U.S. Route 1 – Road Safety Audit

Post Road West, Post Road East, and State Street East

September 12, 2018

Figure 14. Uneven Cracked Pavement

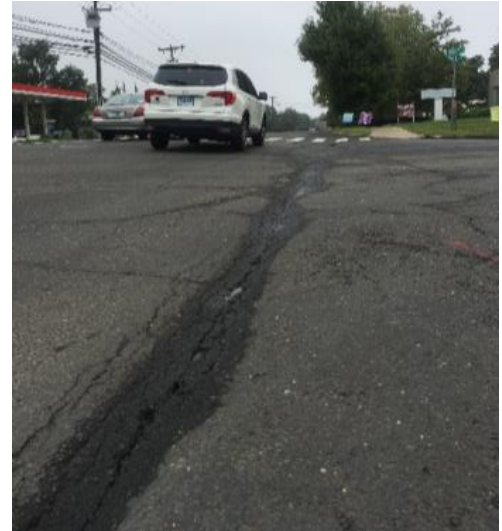
- There is an elementary school to the north of US-1 on Maple Avenue.
- Congestion is heavy on southbound Maple Avenue at arrival and dismissal times.
- Pavement is uneven and there is a significant dip travelling from Maple Ave over US-1 (Figure 14).
- There are multiple, large curb cuts for retail access on north side of US-1.
- The north-east corner radius is undefined. The store parking continues around the building with no definition of a corner edge of road. Plans are to close off the parking area and to add sidewalks along US-1 as part of the redevelopment of this site.

Figure 30. Long Term Recommendations -1

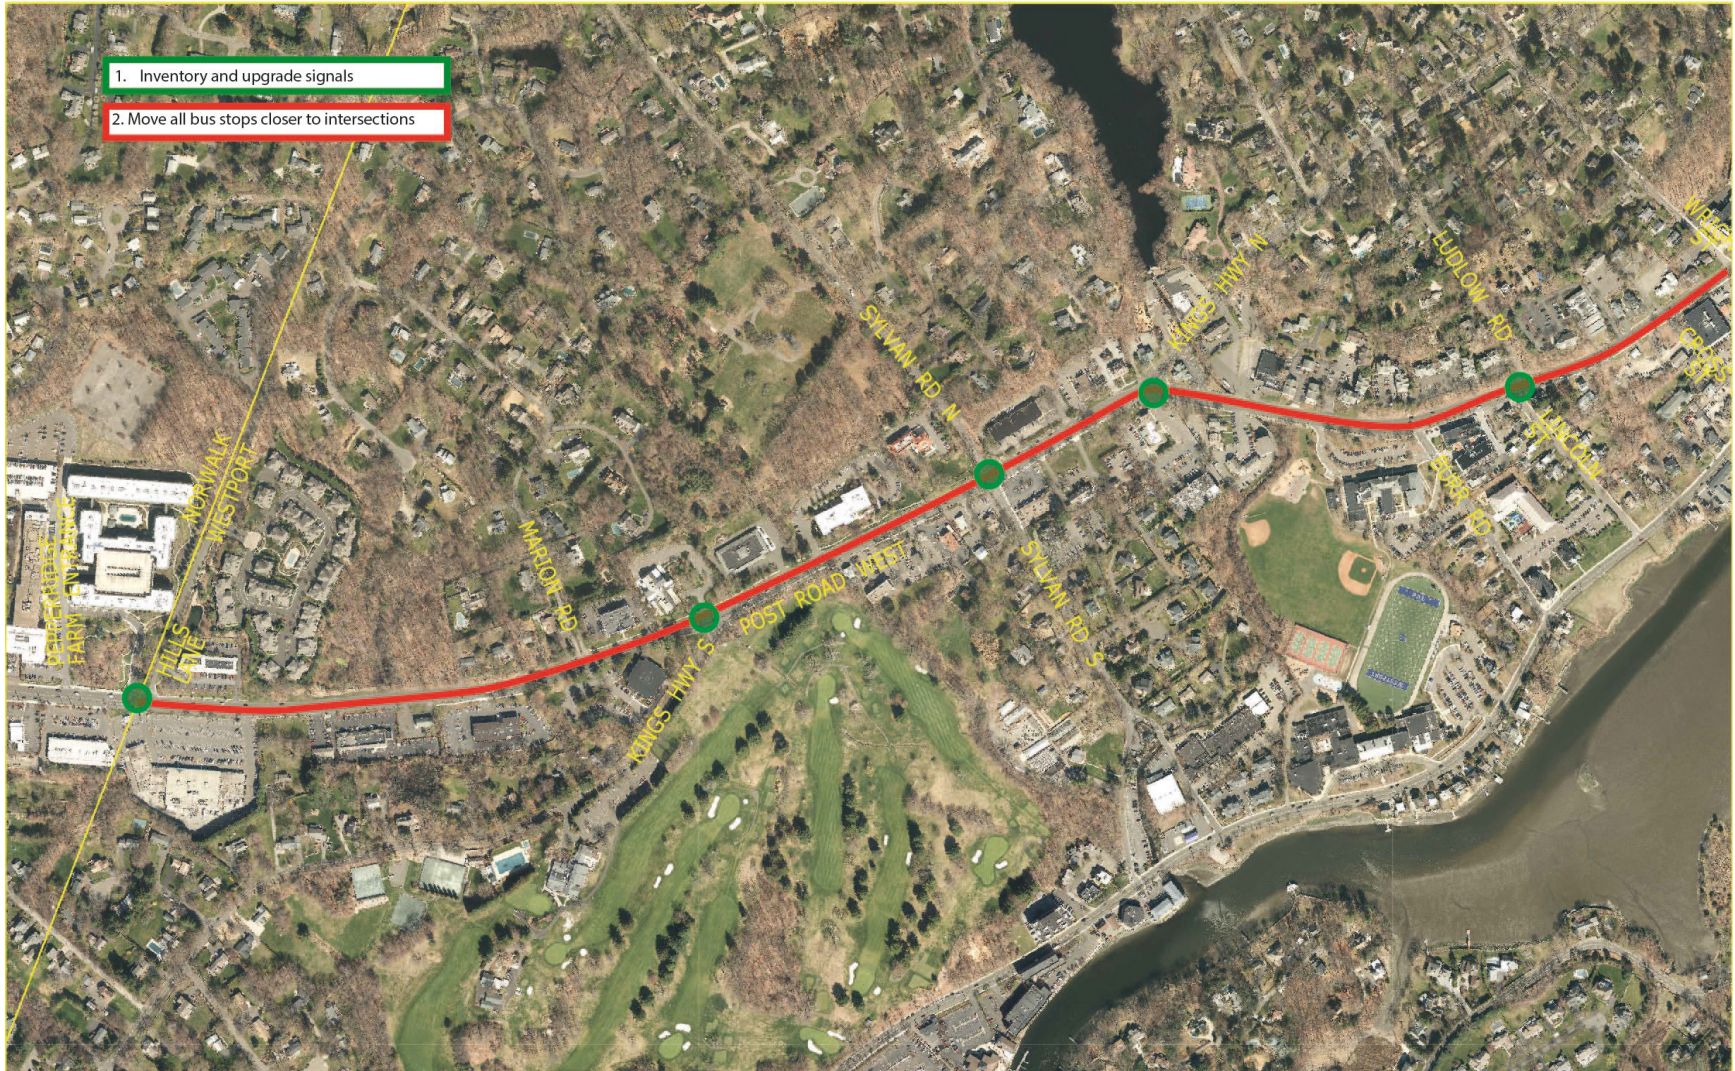
3. US-1/Compo Shopping Center/Trader Joes
 - a. Coordinate with owner of Compo Shopping Center to align their driveway with Trader Joes.
 - b. Relocation of one utility pole may be necessary.

- c. Relocate the pedestrian crossing to the revised intersection location.
 - d. ADA accessible ramps should be constructed.
 - e. The signal should be upgraded to provide ADA compliant pedestrian signals and pushbuttons.
